DAVE BAXTER
Vice President
Oconee Nuclear Station

Subject: Duke Energy Carolinas, LLC
Oconee Nuclear Site, Units 1, 2, and 3
Docket Numbers 50-269, 50-270, and 50-287
Request for Additional Information associated with the License Amendment
Request (LAR) for Low Pressure Service Water Reactor Building Waterhammer
Prevention System Modification
LAR No. 2006-05

REQUESTS FOR ADDITIONAL INFORMATION

UFSAR Mark-ups NSM ON-x3117
LPSW RB Waterhammer Prevention System Description

Unit 2 only
 UFSAR Figure 9-12 (Unit 1 & 2)
 Low Pressure Service Water System

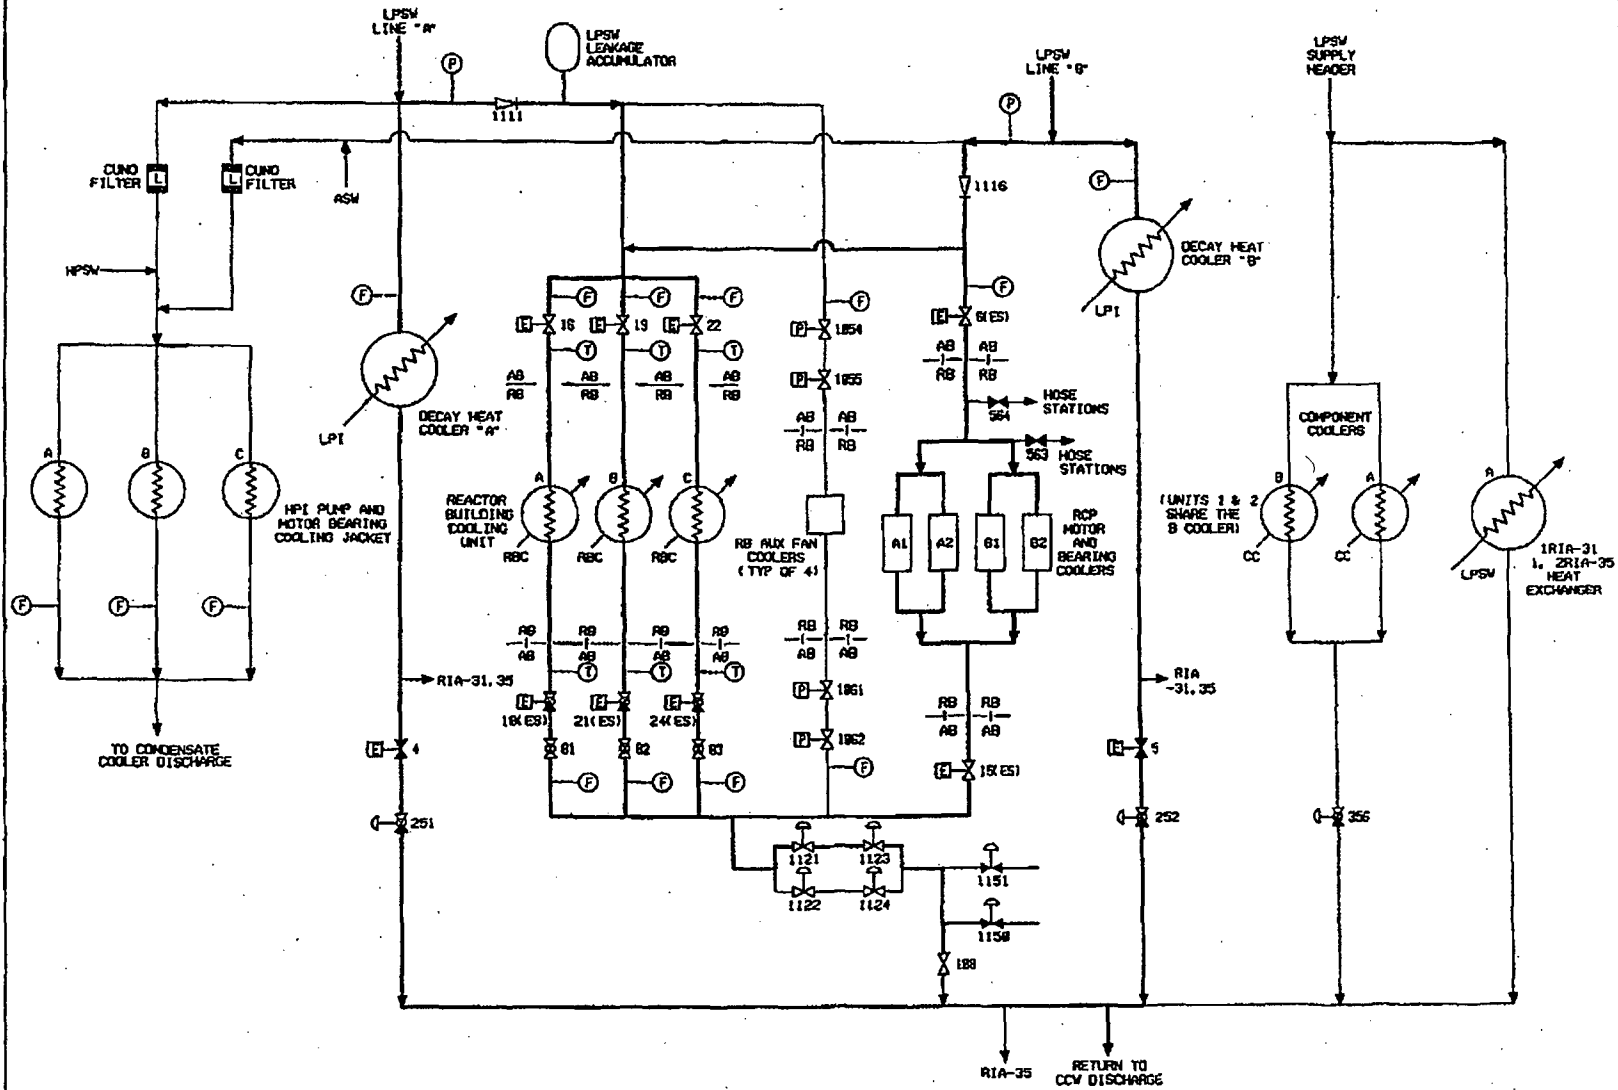
Insert into UFSAR 9.2.2.2.3 at end

Generic Letter 96-06 required consideration of effects inside containment due to the change in environment during a Loss of Coolant Accident (LOCA). This consideration identified the potential for waterhammers in cooling water systems serving containment following a Loss of Offsite Power (LOOP) concurrent with a LOCA or Main Steam Line Break (MSLB). Analysis and system testing in response to GL 96-06 concluded that waterhammers could occur in the Low Pressure Service Water (LPSW) system during all LOOP events (e.g., LOCA/LOOP, MSLB/LOOP). The LPSW piping supplies the Reactor Building Cooling Units (RBCU), the Reactor Building Auxiliary Coolers (RBAC), and the Reactor Coolant Pump Motor Coolers (RCPMC). During Loss of Offsite Power (LOOP) events or Loss of Coolant Accident (LOCA) events coupled with a LOOP it was possible to create a Column Closure Waterhammer (CCWH) or Condensation Induced Waterhammer (CIWH) in the LPSW piping and components inside containment. CCWH could have occurred when the LPSW pumps restart following a LOOP and rapidly close vapor voids within the system. CIWH could have occurred when heated steam voids interact with sub-cooled water in long horizontal piping sections.

The LPSW RB Waterhammer Prevention System (WPS) was designed to maintain the LPSW piping inside containment water solid during events which cause a loss of LPSW such a LOOP, LOCA/LOOP, or MSLB/LOOP. The system's major components consist of check valves in the supply headers (LPSW-1111, 1116), pneumatic discharge isolation valves (LPSW-1121, 1122, 1123, 1124), pneumatic vent valves (a.k.a., controllable vacuum breakers) (LPSW-1150, 1151), and associated actuation circuitry. The discharge header from containment is a common header. The header splits into two parallel headers each of which contain two of the pneumatic discharge isolation valves. The controllable vacuum breakers are located on the common header downstream of the pneumatic discharge isolation valves. See Figure 9-12. The actuation circuitry consists of four pressure measurement loops along with necessary components to cause the pneumatic discharge isolation valves to close and the controllable vacuum breakers to open on low LPSW supply header pressure. The circuitry resets and causes a) the pneumatic discharge isolation valves to reopen and b) the controllable vacuum breakers to reclose on increasing LPSW supply header pressure. The circuitry is designed to be single failure proof to open and close the valves. Failure of the pneumatic discharge isolation valves to reopen following system actuation will prevent flow through the Reactor Building Cooling Units as well as other containment loads such as the Reactor Building Auxiliary Coolers and the Reactor Coolant Pump Motor coolers. Provisions to manually fail open the valves are provided. The failure of the controllable vacuum breakers to reclose is inconsequential (i.e., containment heat removal can be accomplished with the valves in the open position). Each pneumatic valve is provided

with an air accumulator to provide a source of air to move the valve and maintain the desired end state for a short period of time. Only for the case of a Station Blackout (SBO) could the air in the accumulator be insufficient to maintain closure of the pneumatic discharge isolation valves for the duration of the SBO. In this case, reliance on the Supplemental Diesel Air Compressors is needed to provide air to make-up any leakage to maintain closure.

The system includes a "leakage accumulator" to allow a reasonable amount of boundary valve leakage while the piping inside containment is being maintained water solid. The leakage accumulator consists of a quantity of water with an air overpressure. The air overpressure will force water into the isolated portion of LPSW should the pressure decrease due to leakage in order to prevent voiding. The leakage accumulator is a passive device and is normally kept charged by LPSW. During an SBO, a HPSW connection to the accumulator provides extended make-up for leakage. During times when the WPS is out of service, piping code allowable stresses may be exceeded, but pipe rupture is not expected, if an event occurs that produces a waterhammer.
